TypeC
Connector
(こじり強度対策品)

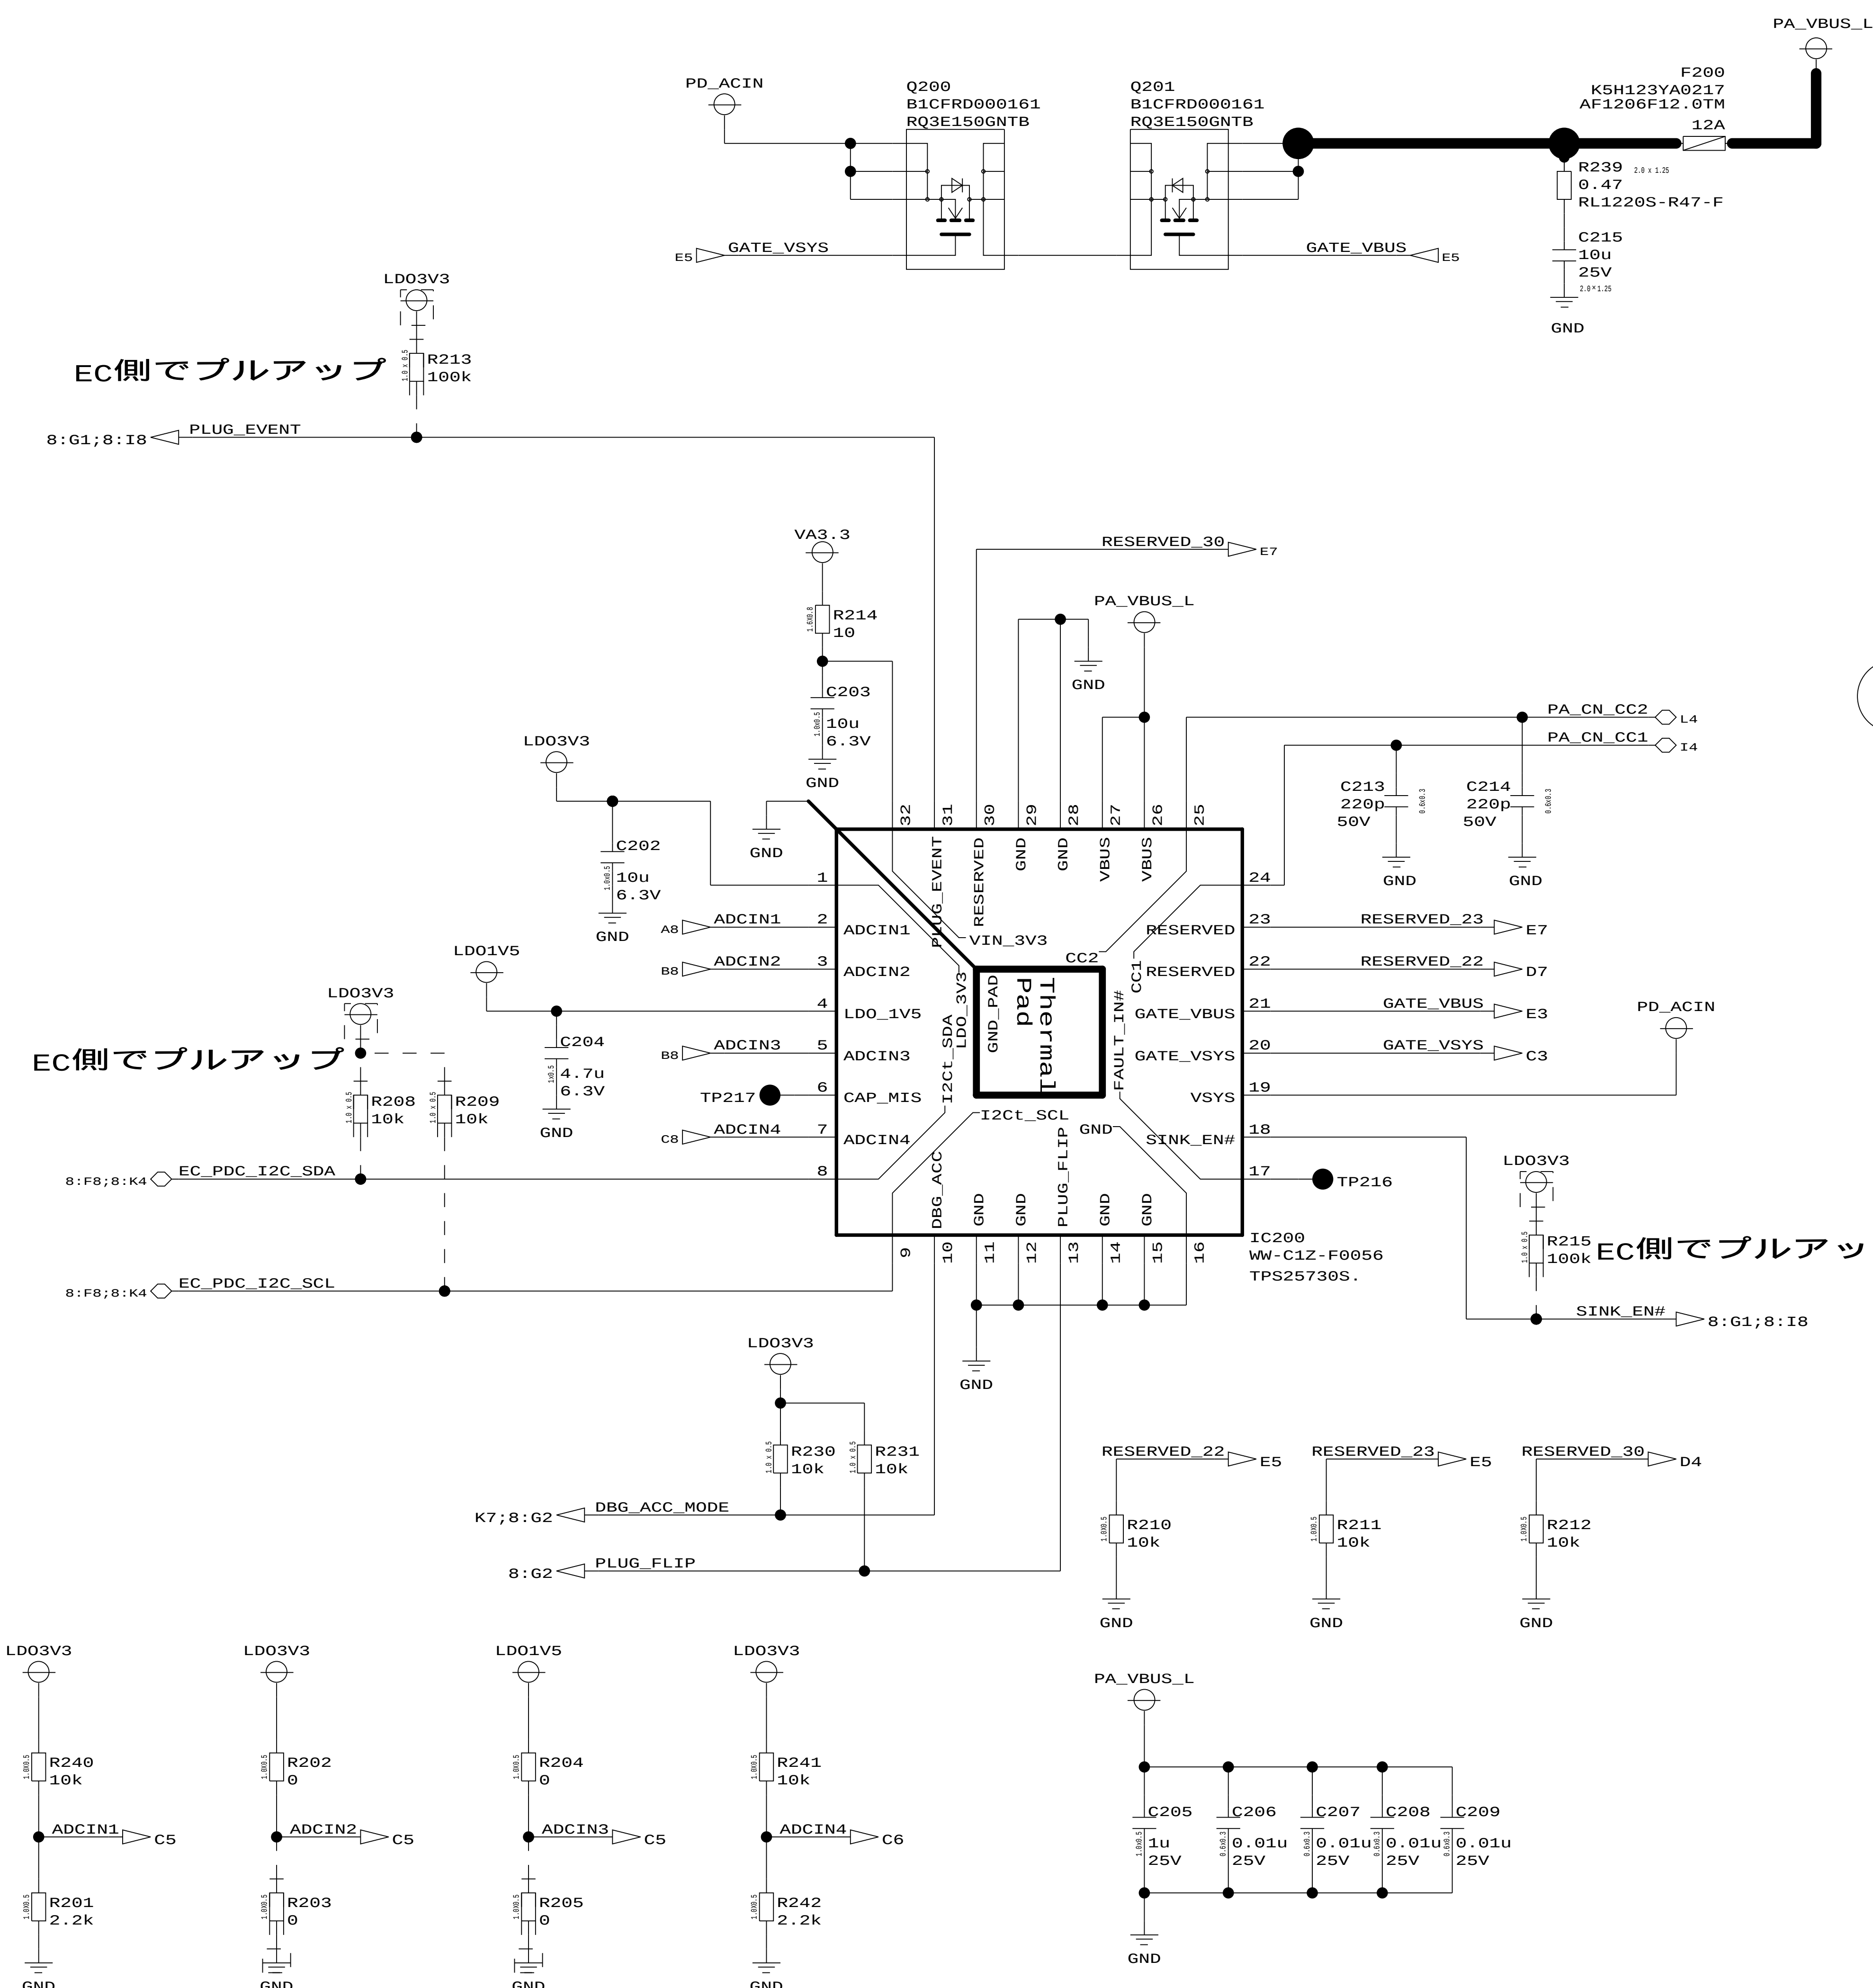
2024/10/15 F200 ヒューズ追加
2024/10/15 R239,C215 スナバ回路追加
2024/10/16 JK200 B列ピンにもUSBライン接続追加
